January 29, 2010
NRC3-10-0007

- References:
- 1) Fermi 3
Docket No. 52-033
 - 2) Letter from Ilka T. Berrios (USNRC) to Jack M. Davis (Detroit Edison),
"Request for Additional Information Letter No. 19 Related to the SRP Sections
2.4.2, 2.4.3, 2.4.5, 2.4.6 and 2.4.13 for the Fermi 3 Combined License
Application," dated December 8, 2009

Subject: Detroit Edison Company Response to NRC Request for Additional Information
Letter No. 19

FIGURE 3, The Guidebook of BMPs for Michigan Watersheds, RIP-14
Exhibit 3
Maximum Depth of Flow for Riprap-Lined Channels

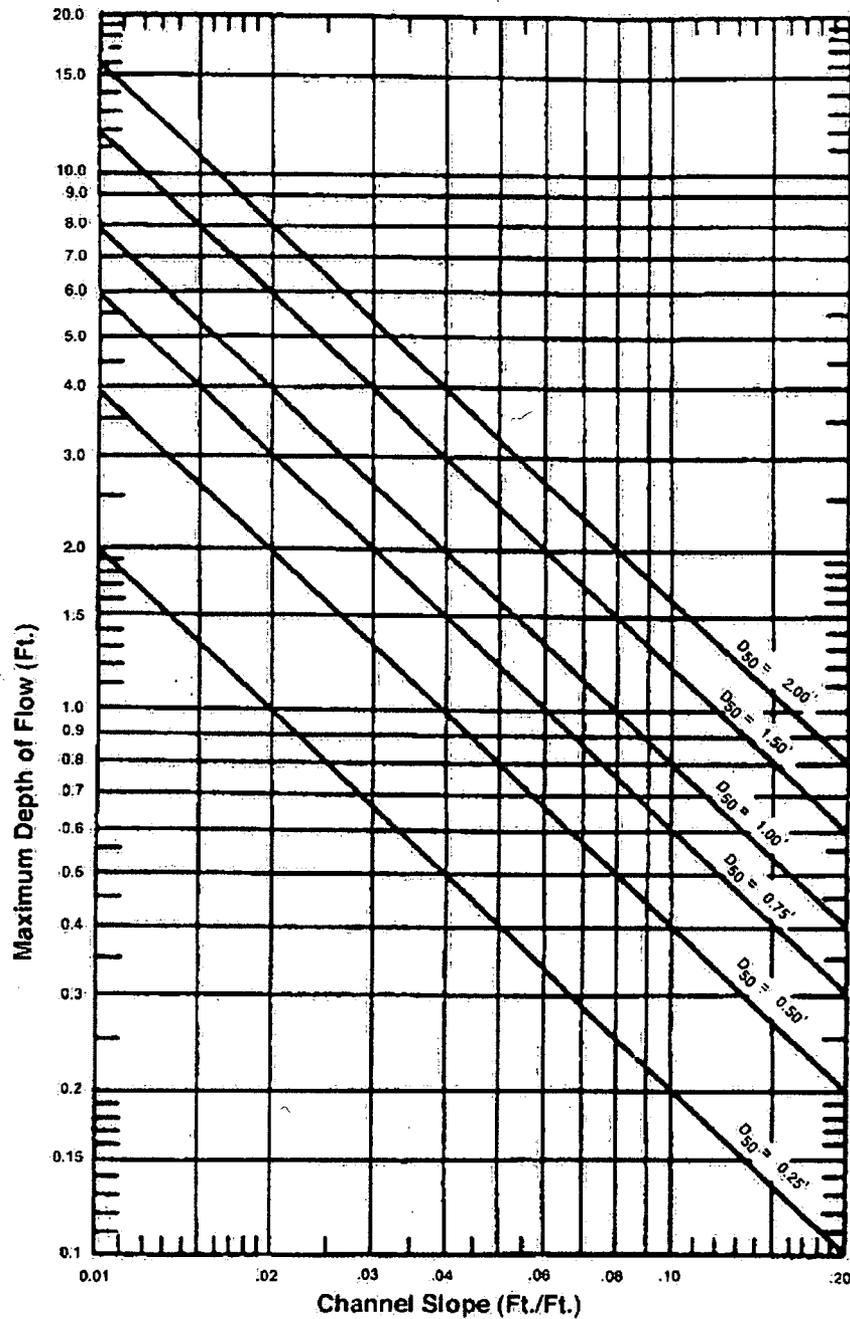
- 1. calculations of the potential maximum velocity of runoff from the 8 percent slopes during the PMP at the site*
- 2. detailed information on specific erosion protection measures designed to resist erosion under the maximum predicted water velocities.*

As discussed in the response to RAI 02.04.02-1, submitted in Detroit Edison letter NRC3-09-0027 (ML092790561), dated September 30, 2009, erosion control measures for the 8% slope of the elevated area will be consistent with design practices included in "The Guidebook of Best Management Practices (BMP) for Michigan Watersheds." The BMP for Michigan Watersheds provides information useful for specifying the erosion control method(s) based on the predicted runoff velocity. As shown above in Table 1, the maximum predicted velocity during a PMP storm event is 5.64 ft/s (based on a final surface of smooth earth); which is greater than the maximum allowable velocity for this soil texture. Figure 1 below, Table 1 of the Stabilized Outlets BMP shows that the maximum allowable velocity for graded loam to gravel is 5 ft/s. To reduce the velocity and prevent erosion, multiple erosion control measures could be incorporated. Grass surfacing would change the n value in Equation 2 above, and reduce the velocity to 4.47 ft/s. Exhibit 4 of the Grass Waterways BMP (Figure 2 below) shows that the permissible velocity for soil established by sod is between 5 and 6 ft/s. As the maximum velocity is less than the permissible velocity, grass surfacing would be an acceptable erosion control measure. Riprap is another erosion control measure that could be used. Using the velocity and depth calculated for sub-basin S2, a D50 of 0.25 feet would be required according to Exhibit 3 of the Riprap BMP (Figure 3). The erosion control measures discussed in this response describe possible measures that could be used. Erosion control measures are not limited to the possible options discussed in this response.

Figure 1
Still Water Elevations for Alternatives IA, II and III

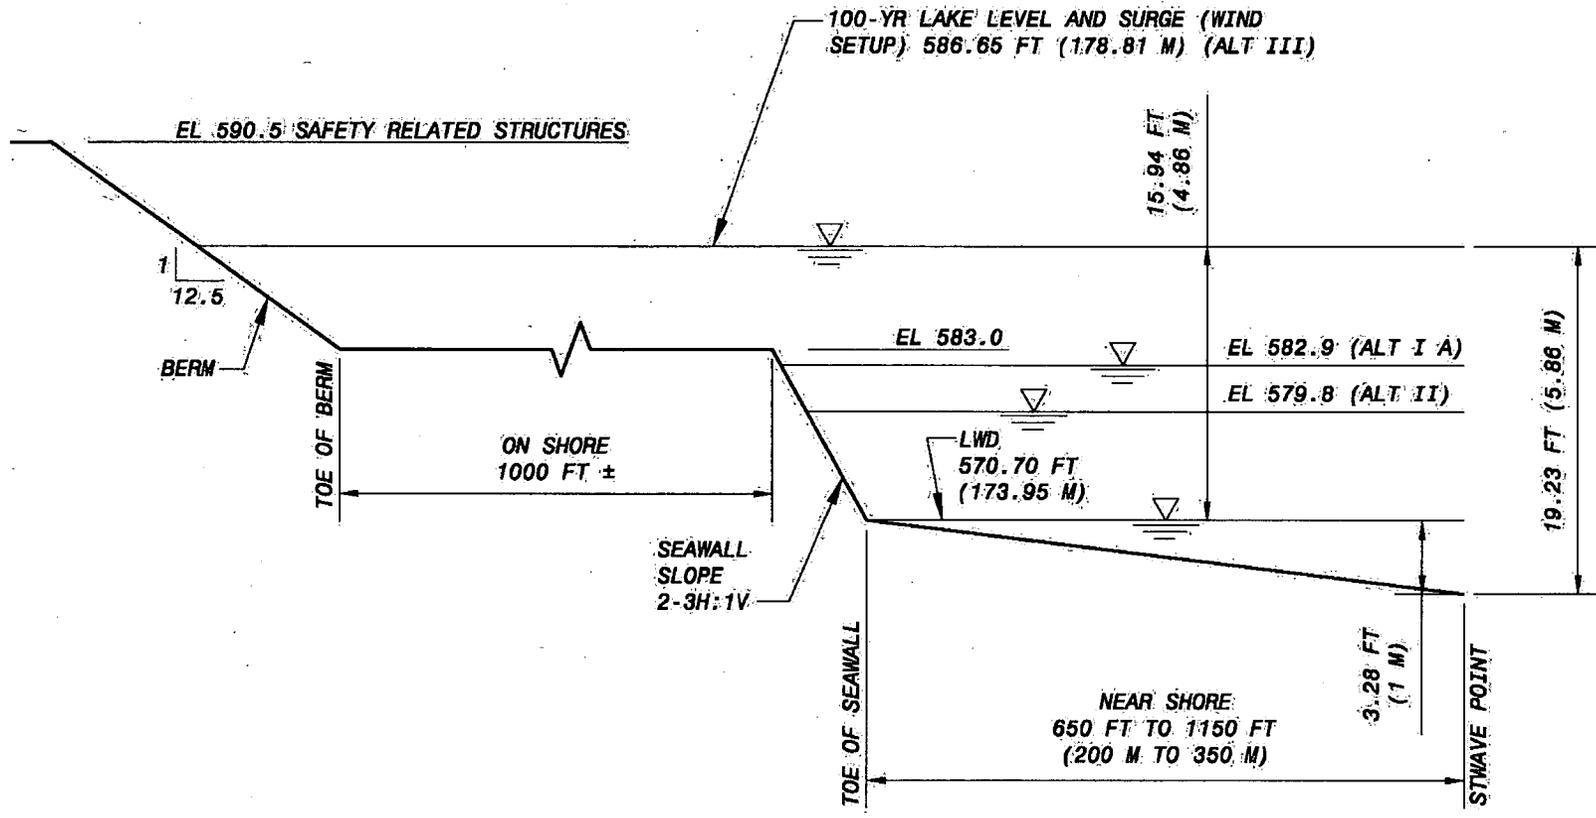
In accordance with 100.20(c) and 52.79(a)(1)(iii) and to support the staff's review of the application, the NRC staff requests that the applicant provide rationale for choosing the 100-year surge as predicted by the USACE for flooding Alternative I rather than using the maximum recorded seiche at the site of 6.3 ft. The ANSI/ANS-2.8-1992 guidelines indicate that the Alternative I should include the "surge and seiche resulting from the worst regional hurricane or windstorm."

Using the 100-year storm surge of 4.0 feet, the predicted water surface elevation for Alternative I was 579.4 ft NAVD88 (580.6 ft PD, plant datum). This represents a 0.3 ft rise over the still water surface elevation in Lake Erie for this condition which would be 579.1 ft NAVD88 (580.3 ft PD). This is 6.0 feet below the still water level predicted for Alternative III, 585.4 ft NADV88 (586.65 feet PD). FSAR Section 2.4.5.3.2.4 indicates that for Alternative III the safety related features would not be impacted by high water levels even with the addition of wave activity. Therefore, it can be concluded that the safety related features would also not be impacted by high water levels under the Alternative I scenario because water levels would be 6.0 ft less than in Alternative III.

If a seiche of 6.3 was used in the Alternative I analysis, the predicted water surface elevation would be approximately 581.7 ft NAVD88 (582.9 PD). This is 3.7 ft below the still water level predicted for Alternative III (586.65 PD). As discussed above, FSAR Section 2.4.5.3.2.4 indicates that for Alternative III the safety related features would not be impacted by high water levels even with the addition of wave activity. Therefore, it can be concluded that even if a seiche of 6.3 feet is used, the safety related features would not be impacted by high water levels under the Alternative I analysis, including the higher surge elevation scenario, because water levels would be 3.7 ft less than the Alternative III analysis.

Figure 1 shows the still water elevations for all three alternatives. On Figure 1 the seiche height of 6.3 feet was used in place of the 100-year storm surge of 4.0 ft for Alternative I (identified as Alternative IA on the attached figure).

FIGURE 1, Bretschneider Method Variables

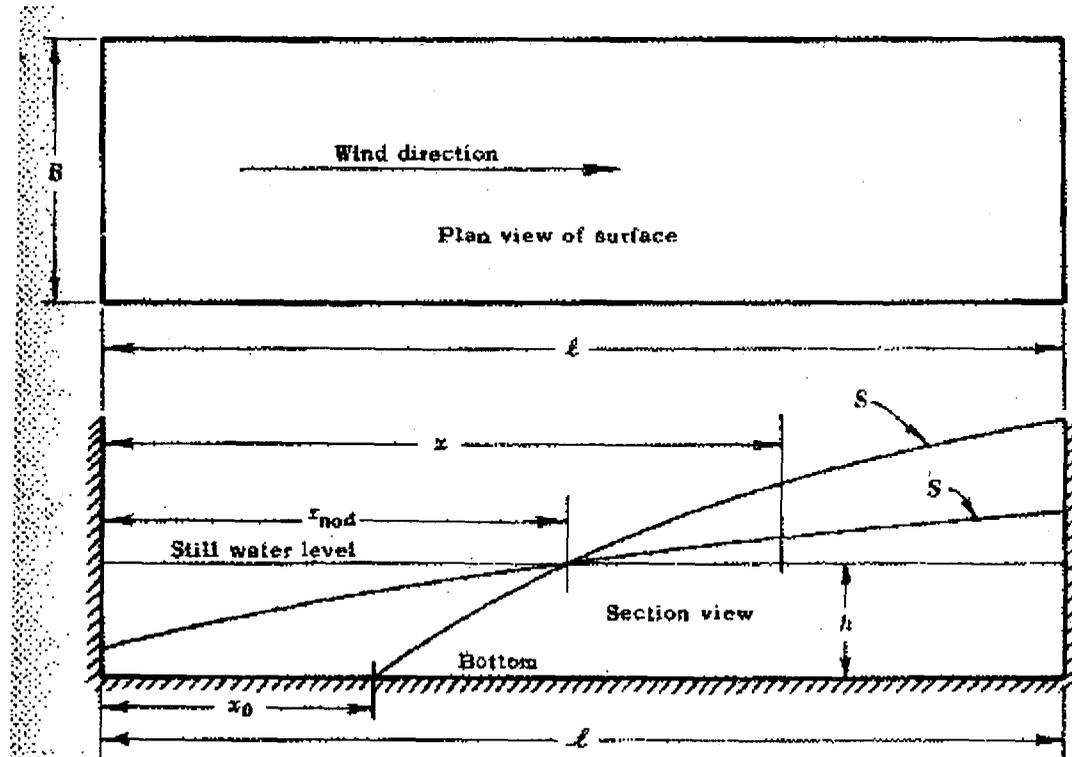
To meet the requirements of 10 CFR Part 52 and 10 CFR Part 100 and to support the staff's review of the application, the staff requests that the applicant provide the following: (1) descriptions of the limitations of the Bretschneider method used for calculating wind setup under the PMWS, (2) rationale of choosing the Bretschneider method as a conservative approach to predict the probable maximum surge for Lake Erie compared to other commonly used methods, (3) details on the derivation of the key parameters of fetch length and water depth used in the Bretschneider method, and (4) a table of results presented in applicant's calculation package.

The table of results from the calculation file is presented below (Table 1). Figure 1 is included to illustrate variables that were used. The table lists the calculated values for each of the 10 segments along the transect of the lake. The stress parameter is calculated according to the equation listed under Note A and is a function of wind speed, fetch length and water depth. The ratio of wind set-up (S) to water depth (h) was interpolated from values presented in tables provided in FSAR Reference 2.4-257. The specific values for stress parameter and ratio (S/h) used in the interpolation are listed in the table below and marked as the high and low values.

Figure 1

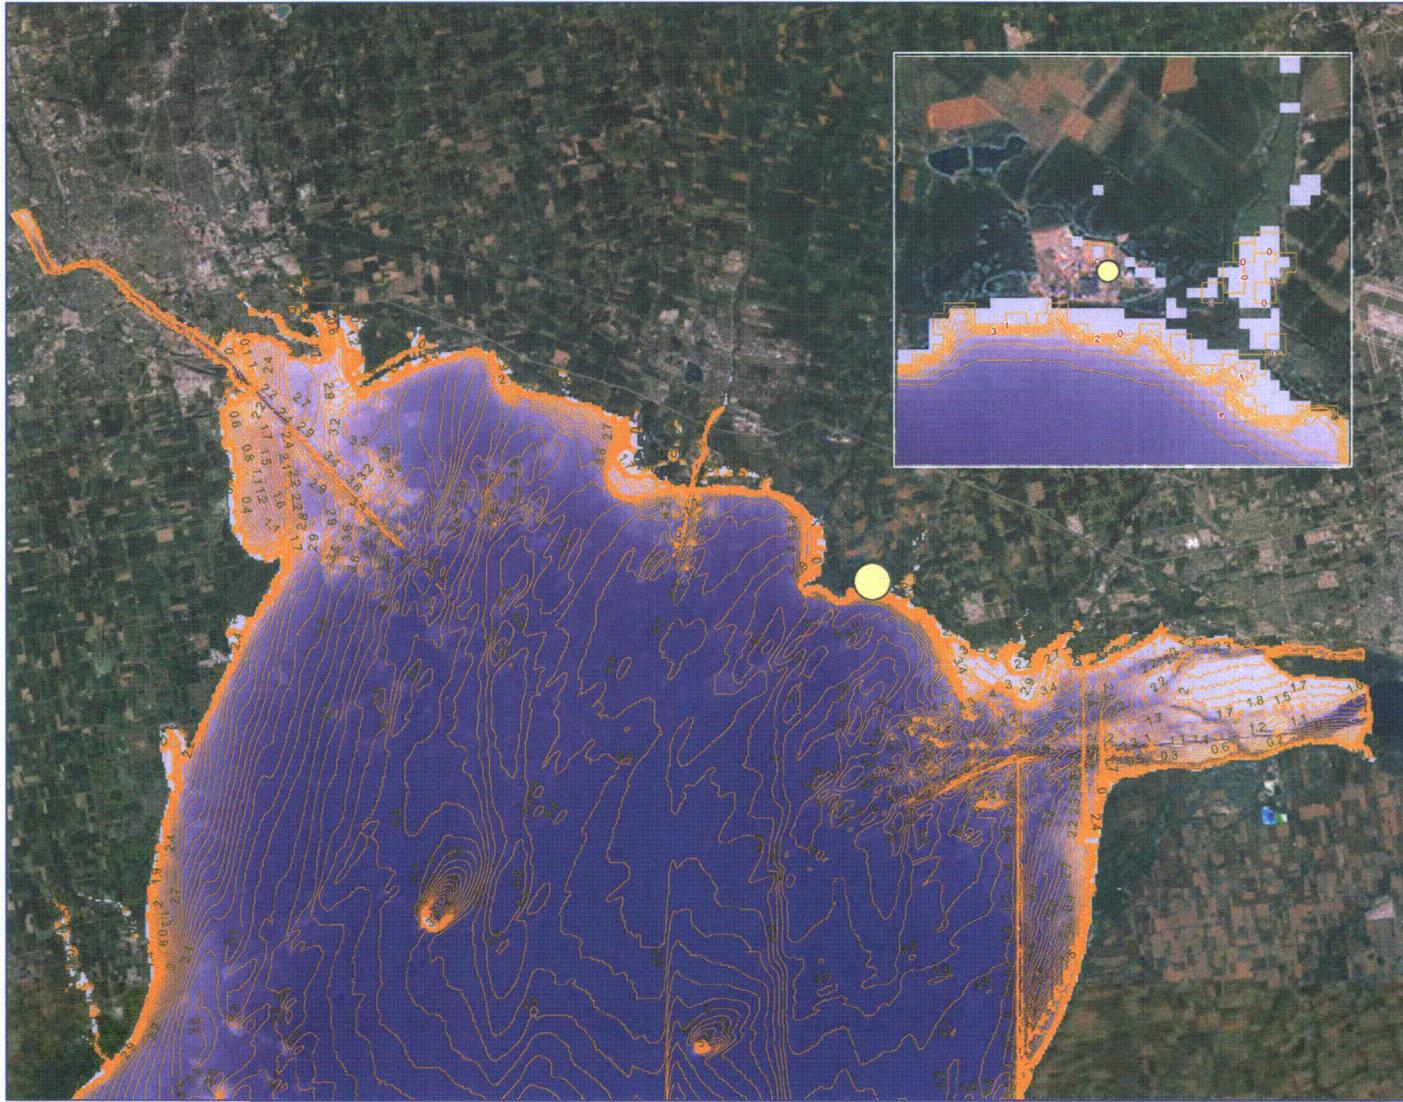
To meet the requirements of 10 CFR Part 52 and 10 CFR Part 100 and to support the staff's review of the application, the staff requests that the applicant provide a map showing the distribution of wave height overlain on the contours of the bathymetric map of Lake Erie. According to section of 7.3.5 of ANSI/ANS-2.8-1992, "Results of the computation of the probable maximum surge hydrograph in graphical presentation" should be addressed.

Figure 1 provides the contours of the wave height distribution overlain on the bathymetric map of Lake Erie from NOAA (NOAA Great Lakes Environmental Research Laboratory, <http://www.glerl.noaa.gov/data/char/bathymetry.html>). The wave height contours were prepared using the results from the STWAVE analysis. Wave heights are in meters and the contours have 0.1 meter accuracy.

Figure 1

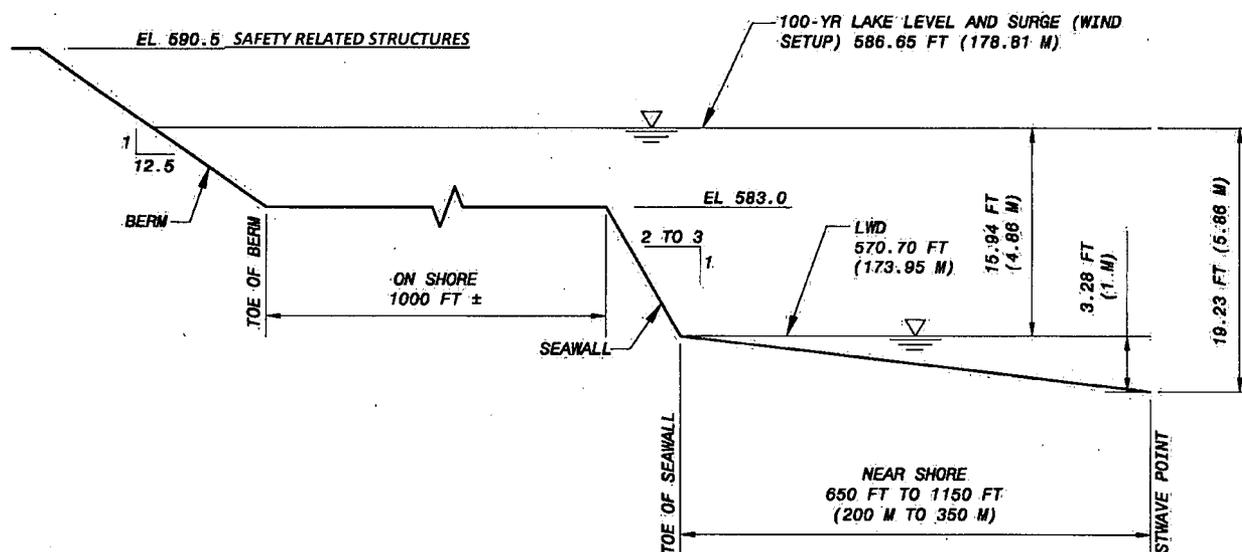
- 1. Revise FSAR Table 2.4-224, Breaking Wave Heights, to show correct and consistent values of wave height in meter and feet, respectively, and*
- 2. Use graphs to illustrate the shore profile (from STWAVE point to the Fermi 3 safety structure), wave characteristics across the shore (maximum still water level, wave length, wave height, breaking wave, run-up, etc.), their relationship, and quantitative information that supports conclusion of no impact to Fermi 3 safety structures.*

(2) Graphs are provided below, that indicate wave characteristics at three locations across the shore, at the toe of the seawall, at the toe of the berm, and the final run-up on the berm. These graphs show the still water level, wave height, wave length, and run-up characteristics. In addition to the graphical presentation, the values of the wave characteristics are summarized below for each location.

Figure 1 presents a cross section showing a transect between the Fermi 3 site to the grid point. Ground elevations and the still water surface water elevation are shown using the Fermi Plant Datum (PD). Note that because of the horizontal distances included on Figure 1 it is not to scale. However, slopes, elevations and distances are noted on Figure 1. The areas shown on Figure 1 can be described as:
